Re: License Amendment Request, License R-2, Docket 50-005

### ***Evaluation of the Proposed Change***

This amendment request supports the addition of a Reactor Bay Heating Ventilation and Exhaust System (RBHVES) to the reactor bay air handling infrastructure. Following the amendment, the RBHVES is intended to be the primary exhaust system during normal (non-emergency) operations. The Facility Exhaust System (FES) and Emergency Exhaust System (EES) referenced in the Technical Specifications will remain, and the FES will operate as a component of the RBHVES. Updates to the facility Technical Specifications are needed to be able to use the RBHVES to maintain negative differential pressure and to add appropriate surveillances to ensure the differential pressure reading is correct. The FES and EES may still be used when necessary, and the EES will remain the only exhaust system that is used during emergencies.

Figure 6-1 Reactor Bay HVAC and Emergency Exhaust Systems

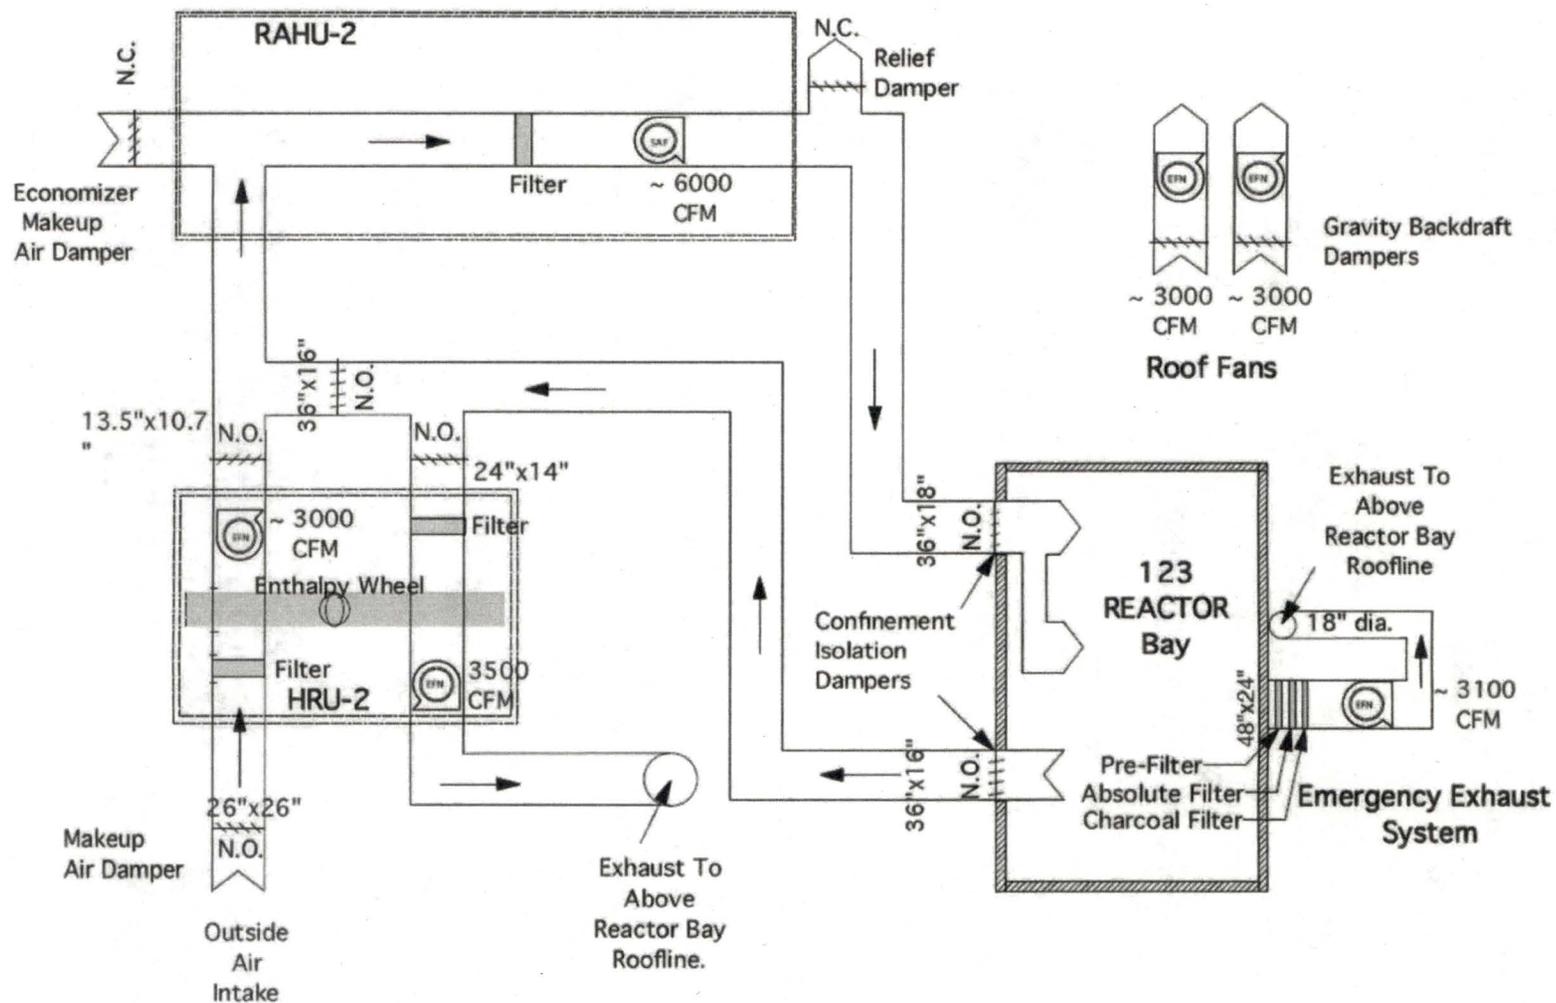
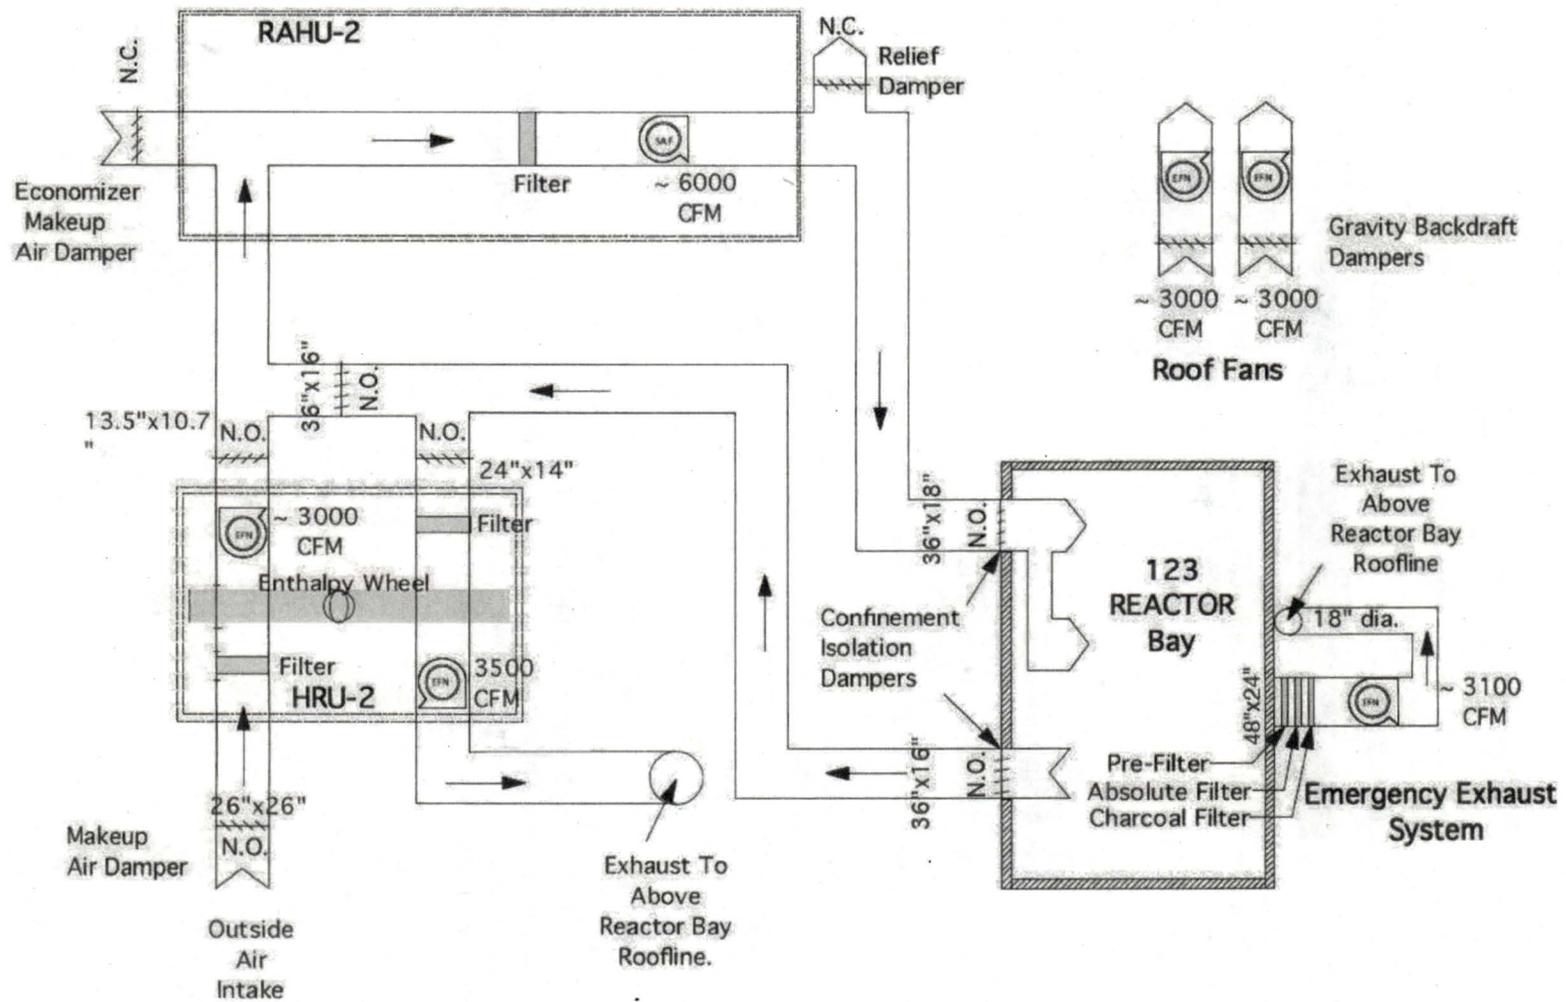
The RBHVES contains an additional exhaust fan and stack that exhausts at reactor bay roof level (i.e., lower than the FES and EES exhaust), a makeup fan with an enthalpy wheel, a recirculation fan, and associated control dampers. Confinement penetration dampers close to isolate the system on system shutdown or power failure. During normal operation using the RBHVES the balance of fresh makeup air and exhaust air maintains a slight negative pressure in the reactor bay. (A system drawing is included in the revised SAR Chapter 6 as Figure 6-1).

The ~70,000 feet<sup>3</sup> (1900 m<sup>3</sup>) minimum volume reactor bay is maintained at a negative pressure with respect to the remainder of the building by one or more of two-four separate exhaust fans/systems (see Figure 6-1). Depending on operational configuration, fresh air to the reactor bay is supplied by leaks around doors, and penetrations and by the supply air fan etc. Normal heating, cooling, ventilation, and negative pressure of the reactor bay is maintained is by the reactor bay RBHVES/facility exhaust system (FES). An filtered emergency exhaust system (EES) is also available.

When the evacuation alarm system is activated, any operating RBHVES fans are shutdown, associated confinement isolation dampers shut, and the EES system starts. The EES creates sufficient negative pressure in the reactor bay so that any movement of radioactive material from the bay would be through the system filters. Air enters the EES through a screened opening in the east wall of the reactor bay about ~14 feet (~4.27 m) above the bay floor (see Figure 6-2 EES System). The air then passes through a pre-filter, absolute filter, and carbon filter that are mounted in a housing [REDACTED]. The three-horsepower exhaust fan (~31400 feet<sup>3</sup>/min or ~9.1 x 10<sup>4</sup> l/min with motor operated damper completely open and clean filters) is also mounted there. Flow can be reduced through the system by adjusting the motorized damper (located at the fan suction) open position. Filtered air exhausts into an 18 inch (46 cm) diameter PVC pipe and stack. The stack travels up the [REDACTED] of the reactor building and exhausts at a point above the reactor bay roof (~3-24 feet or ~7.3 m above ground-reactor bay floor level). [MAT1][MAT2]

The ~70,000 feet<sup>3</sup> (1900 m<sup>3</sup>) minimum volume reactor bay is maintained at a negative pressure with respect to the remainder of the building by one or more of four separate exhaust fans (see **Figure 6-1**). Depending on operational configuration, fresh air to the reactor bay is supplied by leaks around doors and penetrations and by the supply air fan. Normal heating, cooling, ventilation, and negative pressure of the reactor bay is maintained by the RBHVES. A filtered emergency exhaust system (EES) is also available.

When the evacuation alarm system is activated, any operating RBHVES fans are shutdown, associated confinement isolation dampers shut, and the EES system starts. The EES creates sufficient negative pressure in the reactor bay so that any movement of radioactive material from the bay would be through the system filters. Air enters the EES through a screened opening in the east wall of the reactor bay about ~14 feet (~4 m) above the bay floor (see Figure 6-2 EES System). The air then passes through a pre-filter, absolute filter, and carbon filter that are mounted in a housing [REDACTED]. The exhaust fan (~3100 feet<sup>3</sup>/min or  $\sim 9.1 \times 10^4$  l/min with motor operated damper completely open and clean filters) is also mounted there. Flow can be reduced through the system by adjusting the motorized damper (located at the fan suction) open position. Filtered air exhausts into an 18 inch (46 cm) diameter PVC pipe and stack. The stack travels up the [REDACTED] of the reactor building and exhausts at a point above the reactor bay roof (~34 feet above reactor bay floor level).
